## **REGIONAL REVIEW FINDING**

**RE:** Development of Regional Impact (DRI) Review

Name of Proposal: 2023 The Gathering at South Forsyth DRI 3967

DRI 02

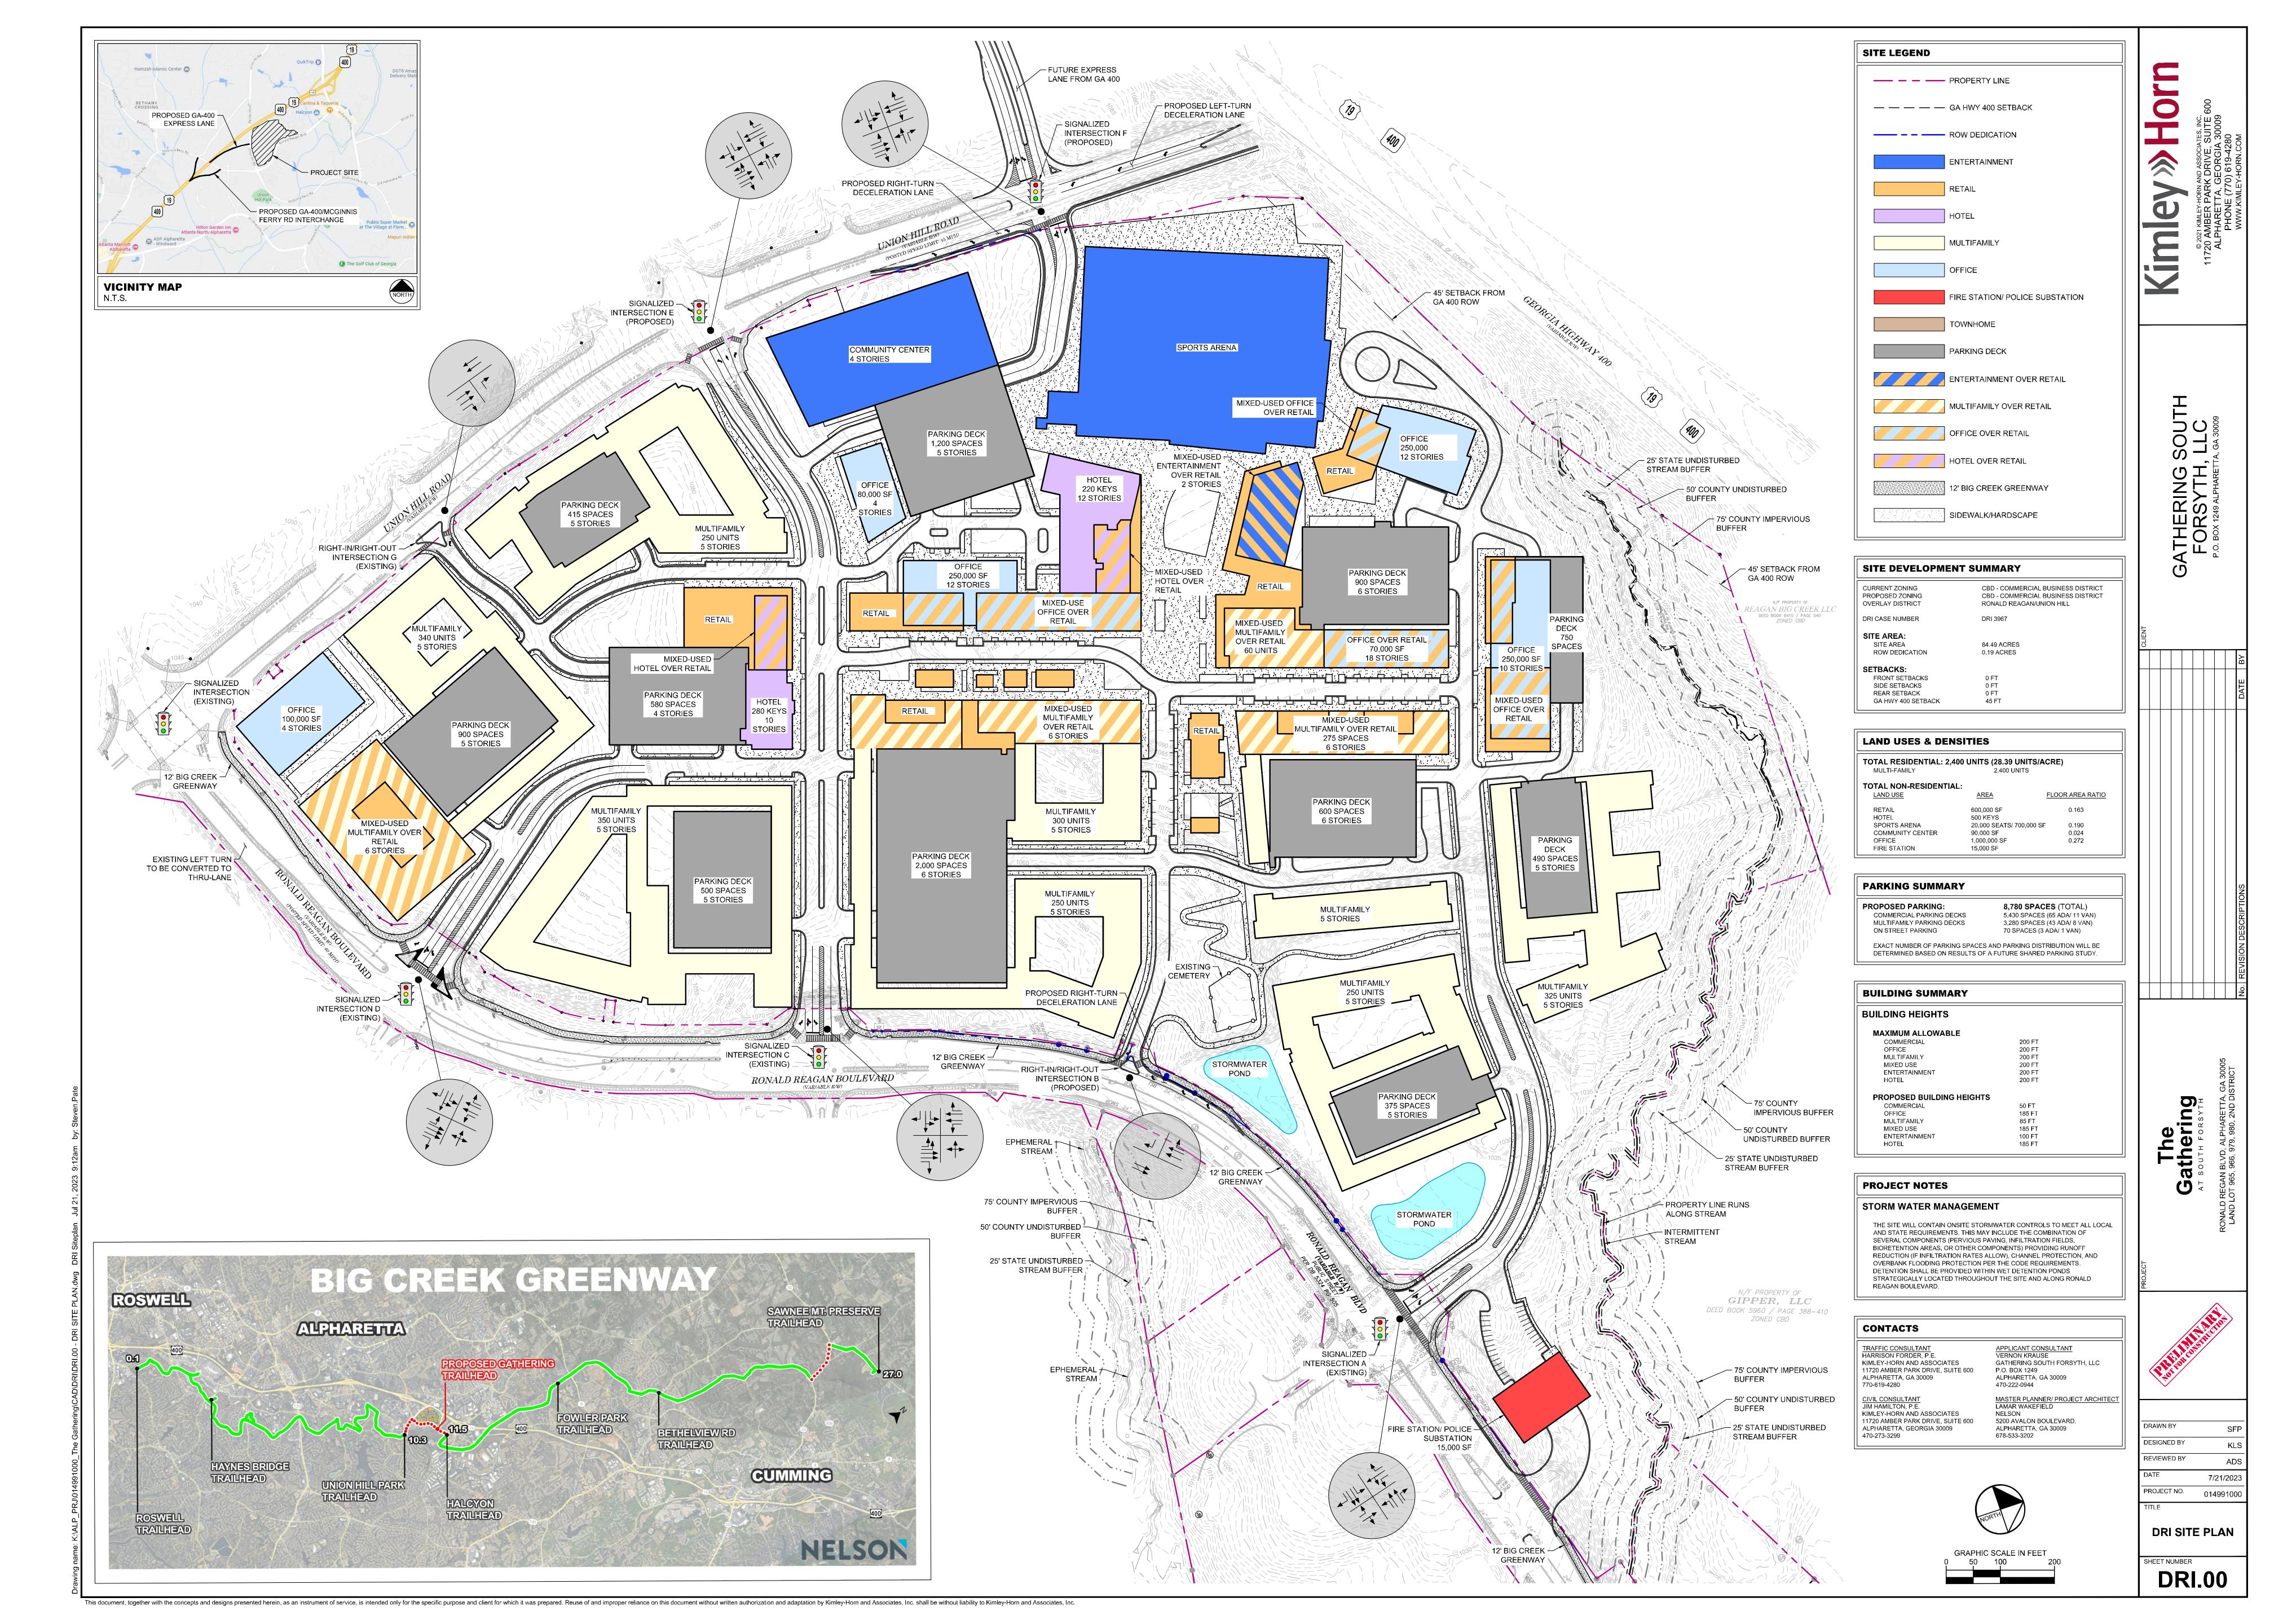
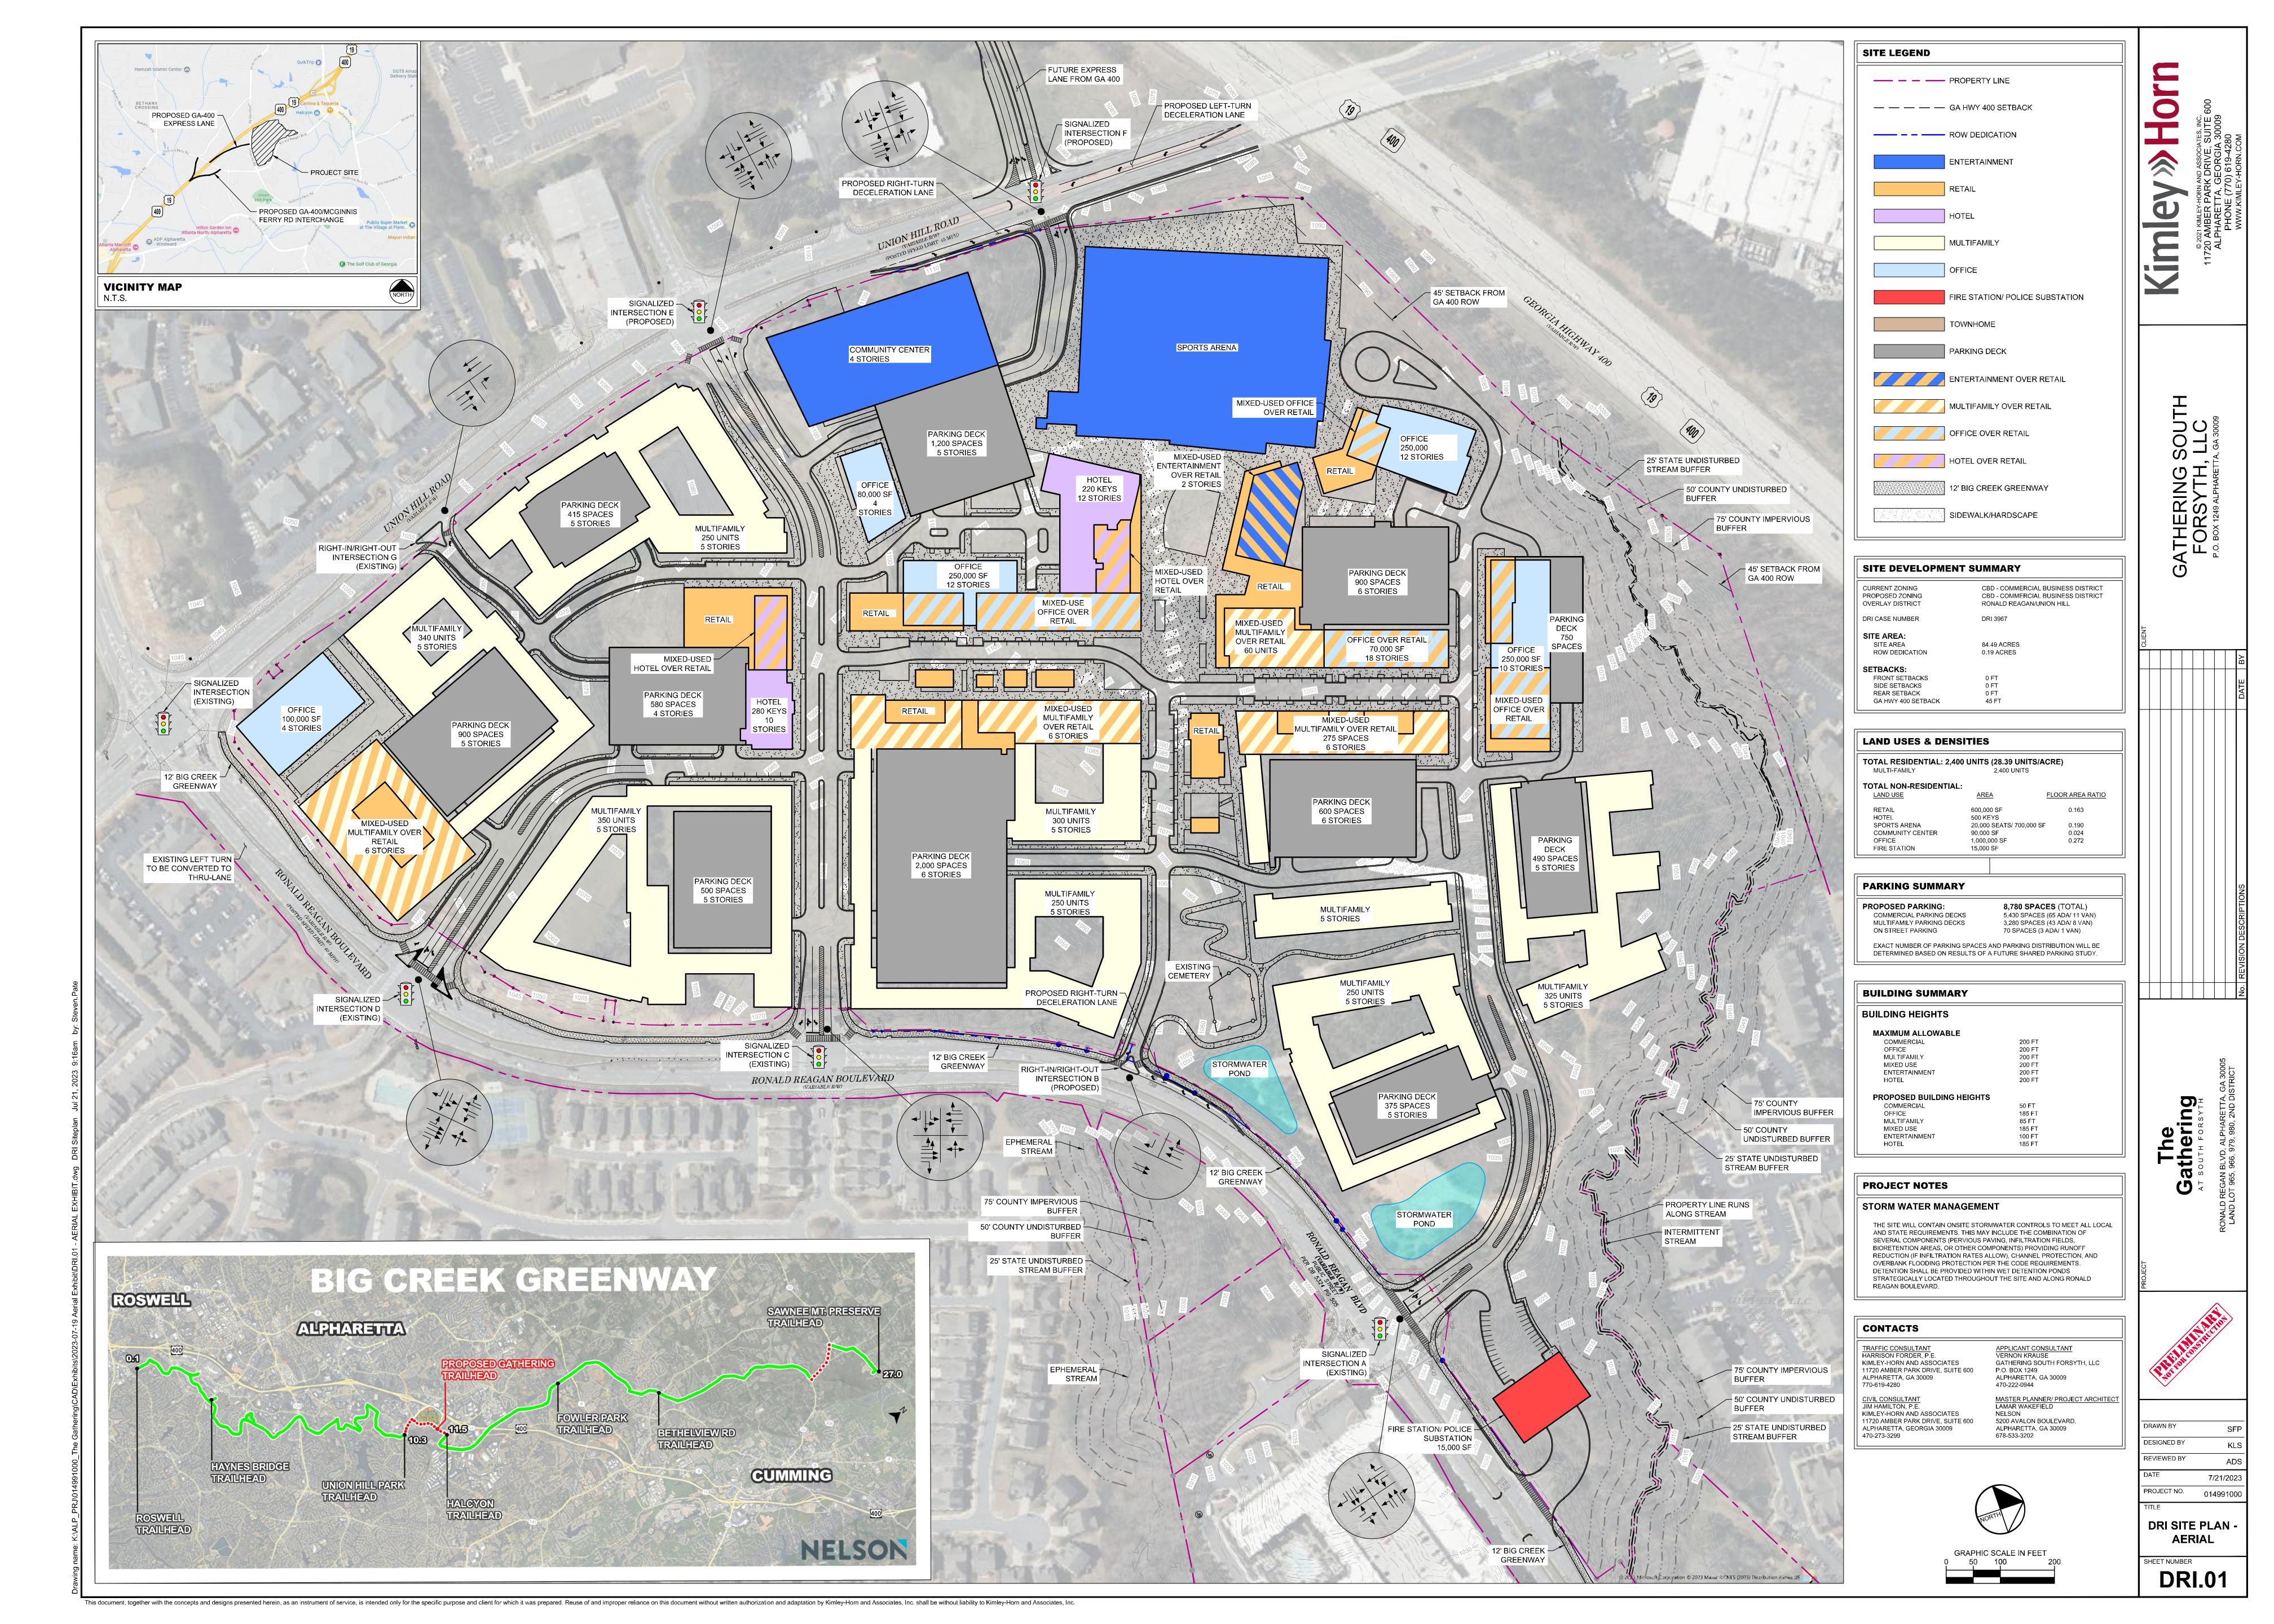
The project includes an extensive internal sidewalk network and the provision of a 12-ft wide segment of the Big Creek Greenway along the Ronald Reagan Boulevard frontage which are supportive of regional altmode transportation policies.

Care should be taken to ensure that the development promotes an interconnected, functional, clearly marked and comfortable pedestrian experience on all streets, paths, entrances, and parking areas. To the maximum extent possible, new driveways and intersection corners where pedestrians will cross should be constructed with minimal curb radii to reduce speeds of turning vehicles and decrease crossing distances for pedestrians.
